**Comanche Peak Nuclear Power Plant, Units 3 & 4
COL Application**

FSAR Revision 2

Update Tracking Report

Figure 8.1-1R Simplified One Line Diagram Electric Power System

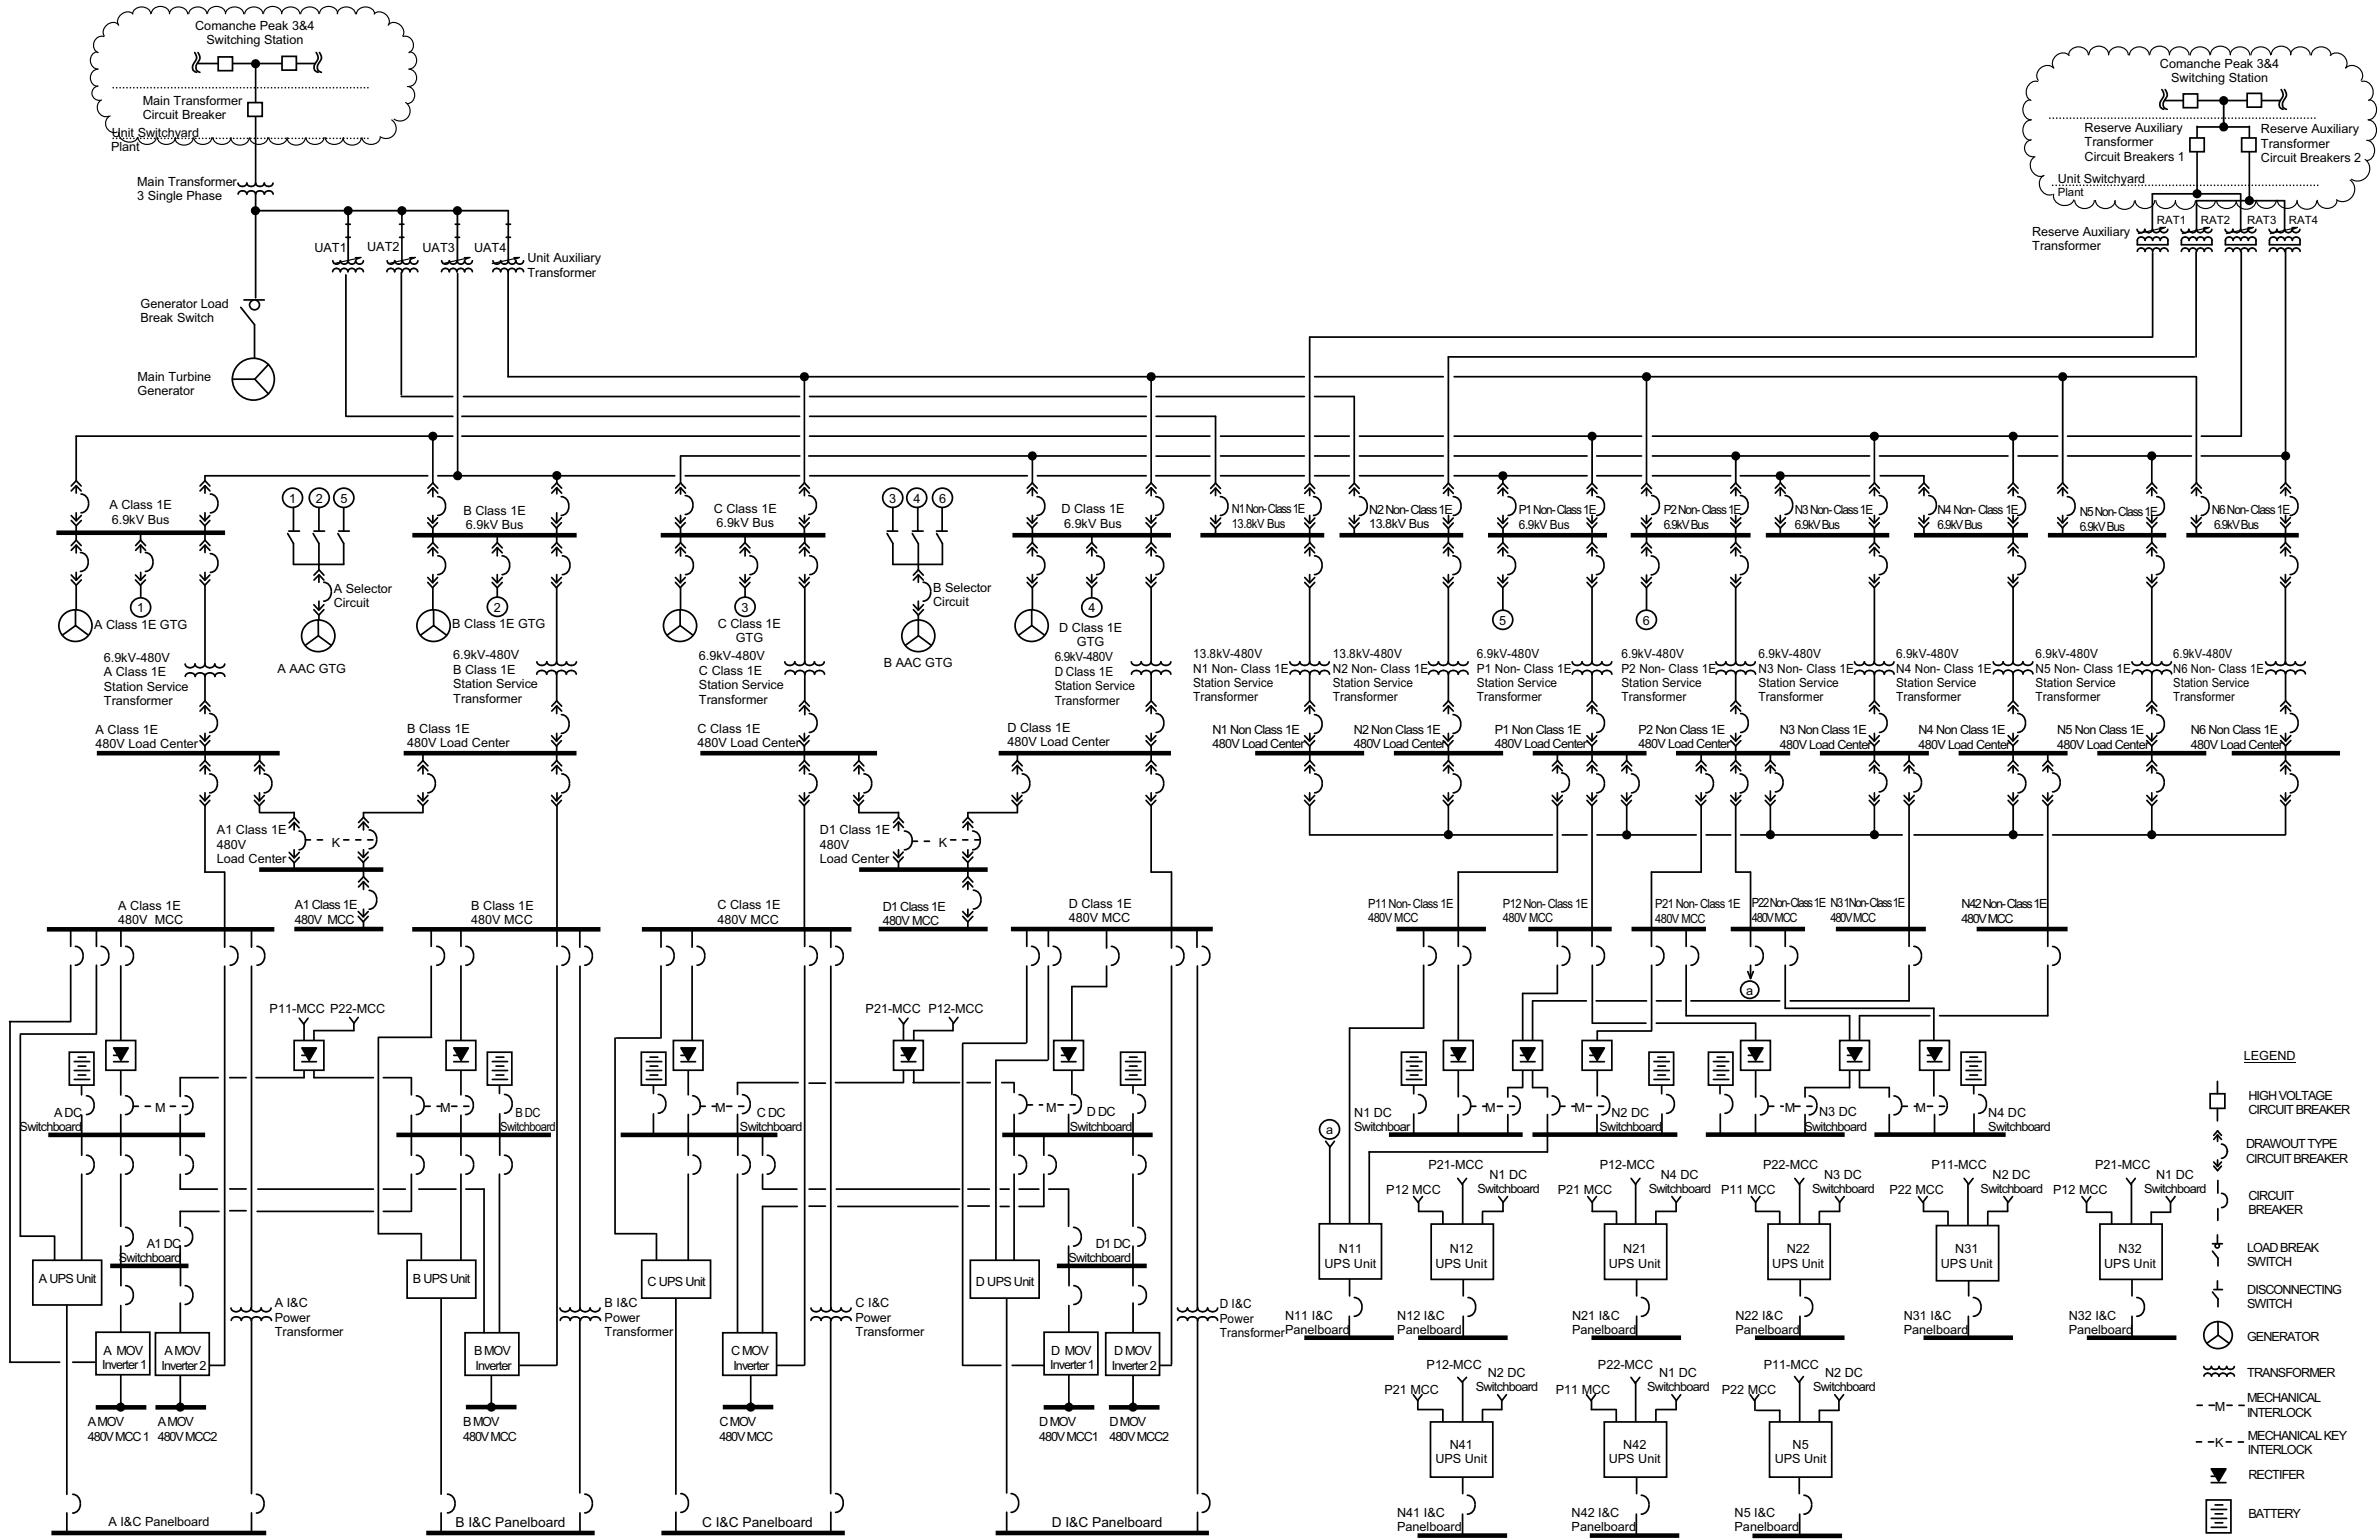
Change ID No.	Section	FSAR Rev. 2 Page	Reason for change	Change Summary	Rev. of FSAR T/R
CTS-01367	8.1.5.3.5	8.1-2	Deleted Subsection	Subsection no longer needed	0
CTS-01369	Figure 8.1-1R	8.1-3	Corrected figure	Replaced Figure 8.1-16 to 1) Deleted the second GLBS shown in the upper Left of Figure 8.1-1R. 2) Corrected the legend for the Battery symbol from "P21 MCC" to "Battery"	0
CTS-01368	8.2.3 8.3.4	8.2-13 8.3-4	Editorial	Deleted, the Following text: "of the FSAR and 8.3.3 of the DCD." Changed STD to CP in LMN	0

Figure 9.2.1-1R Essential Service Water System Piping and Instrumentation Diagram (Sheet 1 of 2)

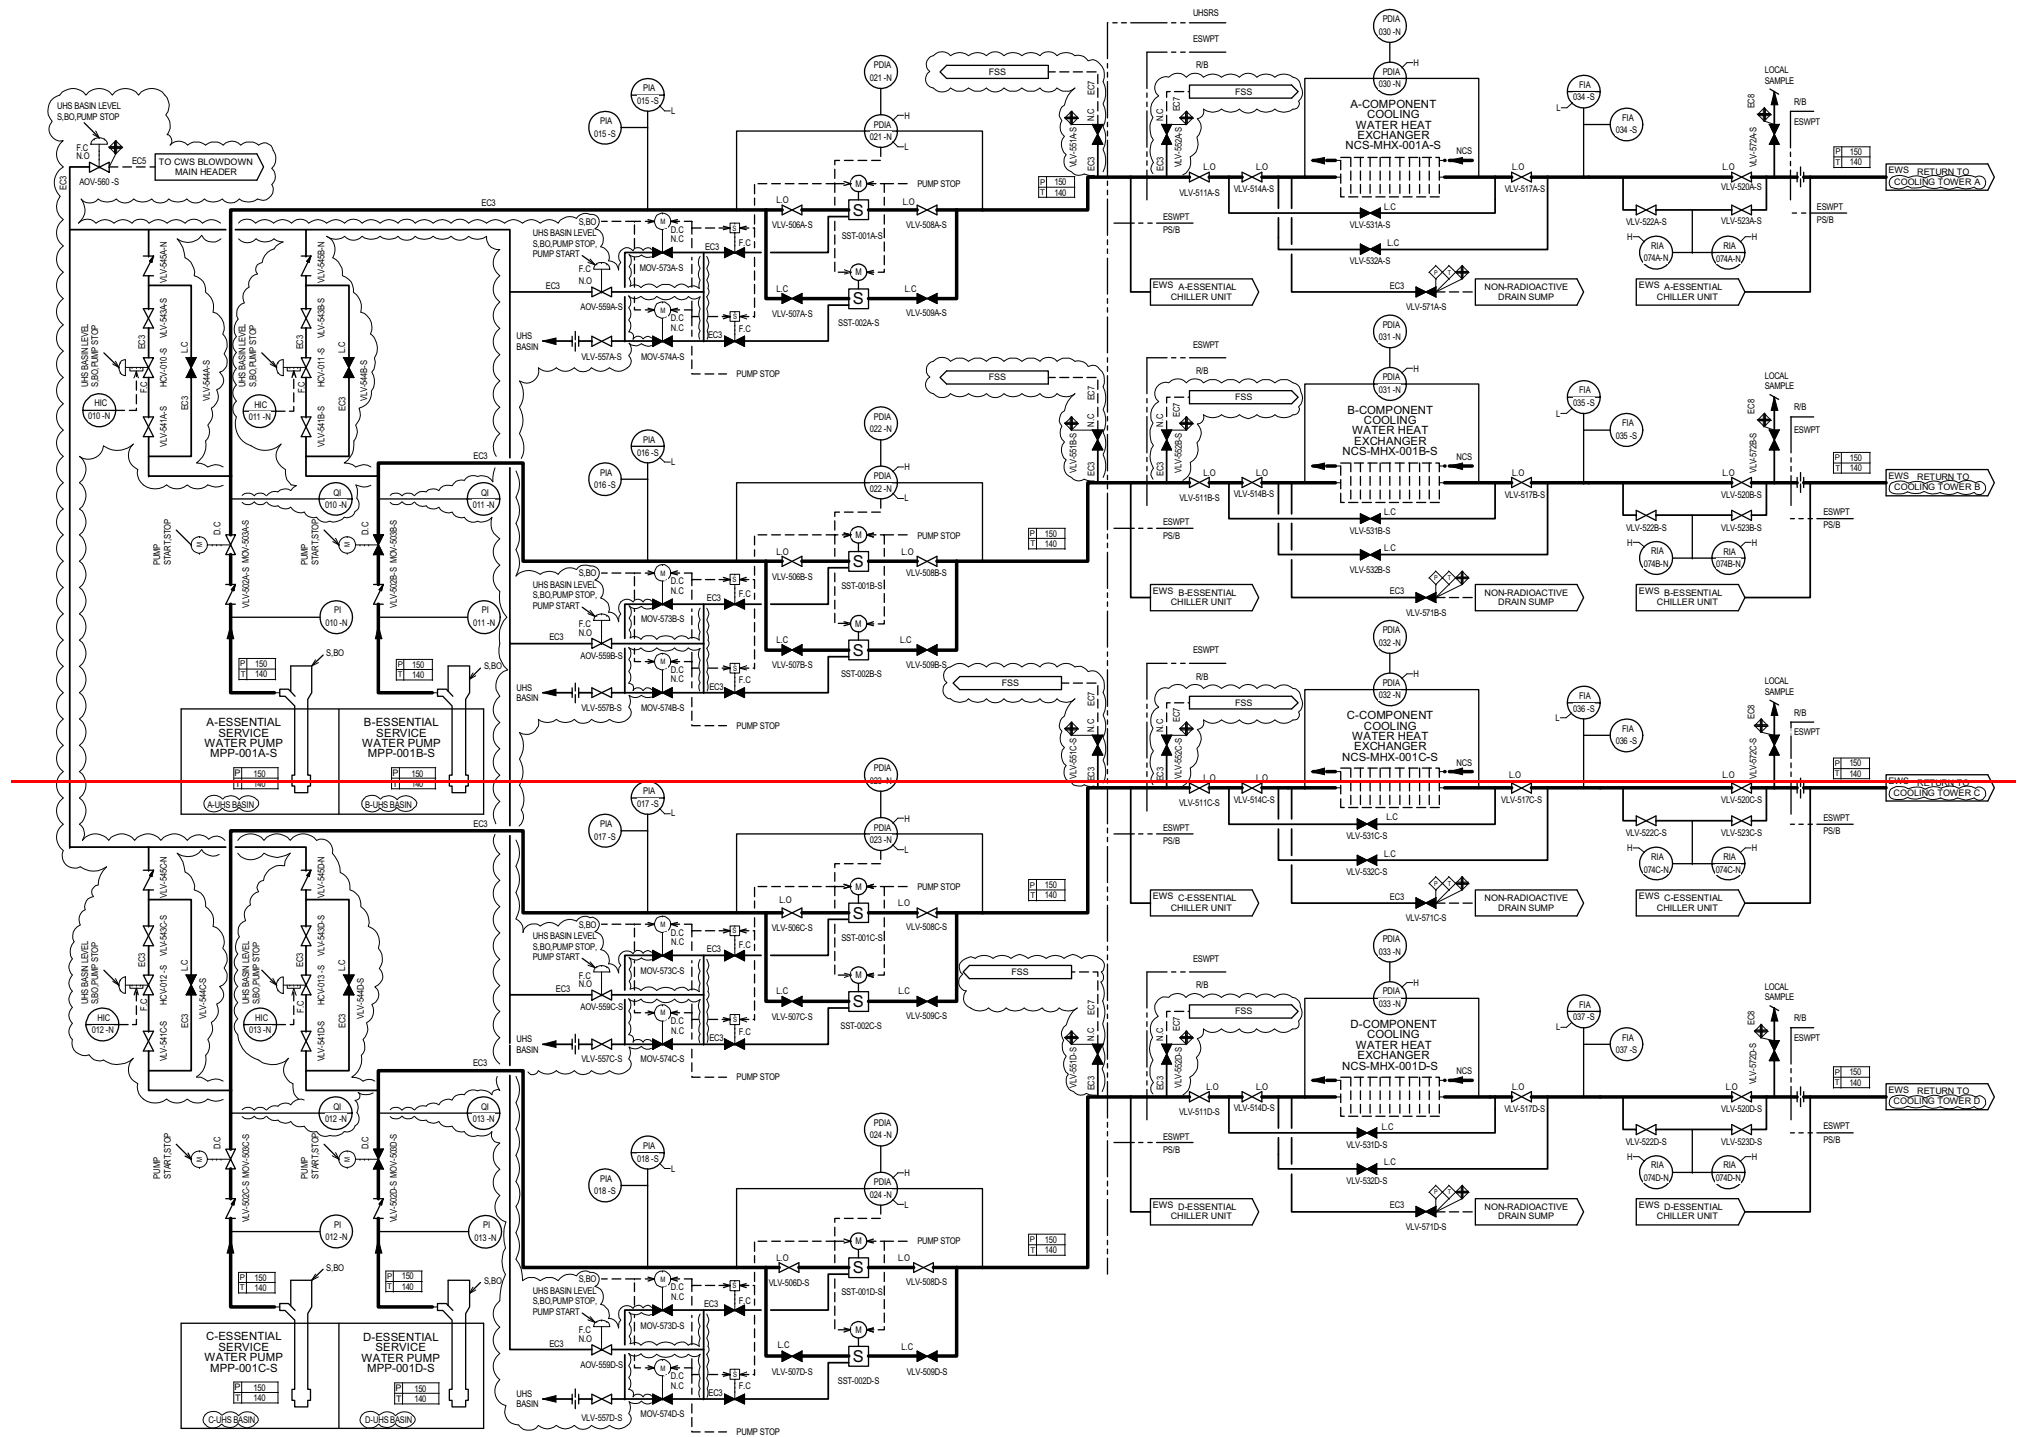
~~Figure 9.2.1-1R shows the piping and instrumentation diagrams (P&IDs) of the essential service water system (ESWS).~~

This COL item is addressed in Subsections 9.2.1.2.4, 9.2.1.2.2.5, 9.2.1.2.3.1, 9.2.1.3 and ~~Figure 9.2.1-1R~~, 13.4, Table 13.4-201.

Figure 9.4-201 Non-Class 1E Electrical Room HVAC System Flow Diagram

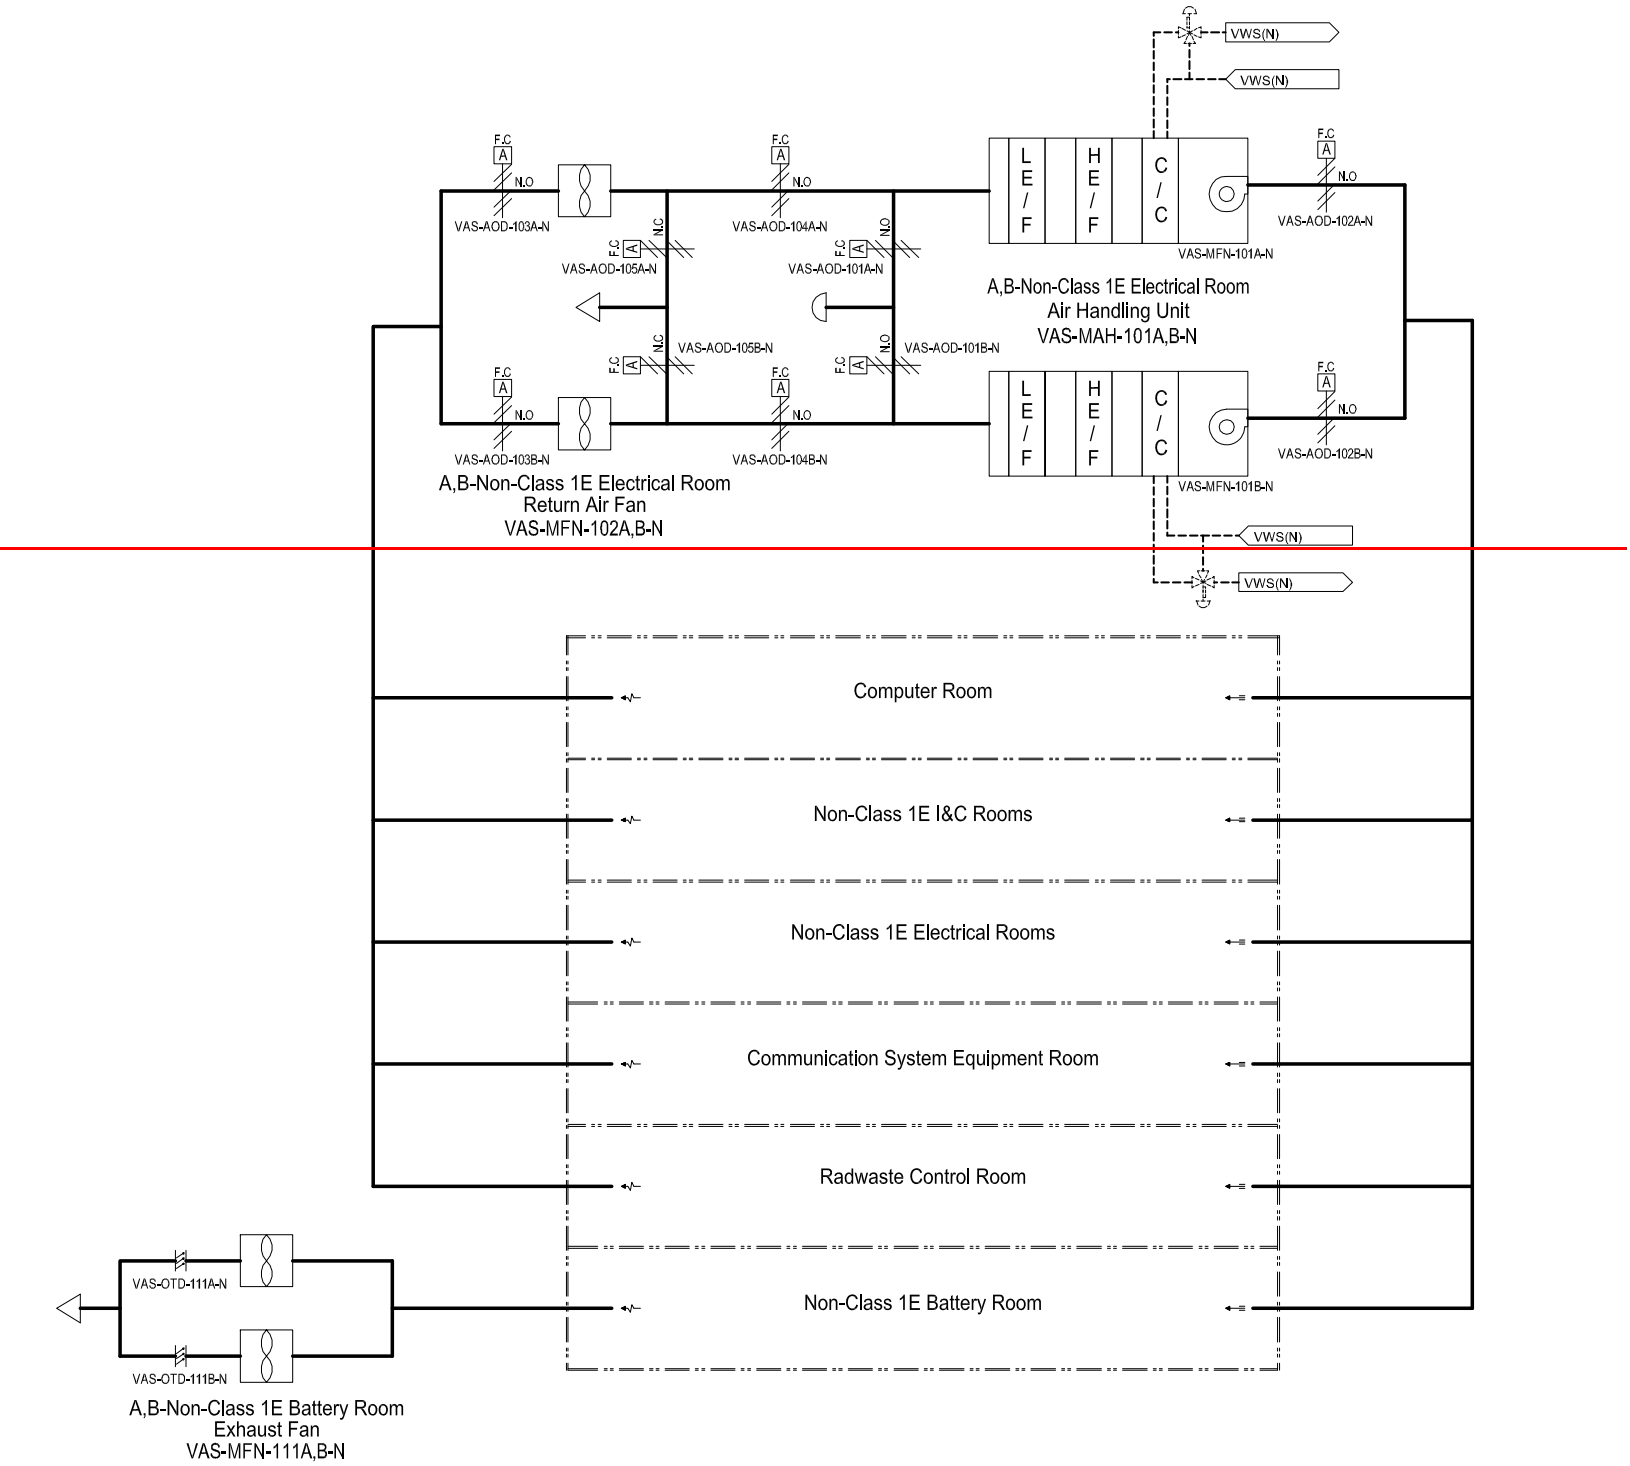
Change ID No.	Section	FSAR Rev. 2 Page	Reason for change	Change Summary	Rev. of FSAR T/R
CTS-01379	9.4.5.2.2	9.4-3	Correction	Removed text reference to Figure 9.4-202 and Table 9.4.5-1.	0
CTS-01380	9.4.5.2.6	9.4-4	Correction	Renumbered Figure 9.4-203 to Figure 9.4-201	0
DCD_09.02.02-72	9.4.7	9.4-8	DCD 09.02.02-72	Clarified COL Applicant requirement for 9.4(4) for heating and cooling coils in air handling units	0
CTS-01378	9.4.7	9.4-8	Correction	Removed Figure 9.4-201 from 9.4(4).	0
CTS-01379	9.4.7	9.4-8	Correction	Removed Figure 9.4-202 from 9.4(4).	0
CTS-01380	9.4.7	9.4-8	Correction	Renumbered Figure 9.4-203 to Figure 9.4-201	0
CTS-01378	Table 9.4-201	9.4-9	Clarification	Added Non-Class 1E Electrical Room AHU heating coil capacity as non-heating	0
CTS-01378	Figure 9.4-201	9.4-18	Correction	Removed Figure 9.4-201. DCD figure is now IBR.	0
CTS-01379	Figure 9.4-202	9.4-19	Correction	Removed Figure 9.4-202. DCD figure is now IBR.	0

~~The non-Class 1E electrical room HVAC system is shown in Figure 9.4-201 and equipment design data is presented in Table 9.4.3-1.~~ The capacity of cooling and heating coils that are affected by site specific conditions is shown in **Table 9.4-201**.
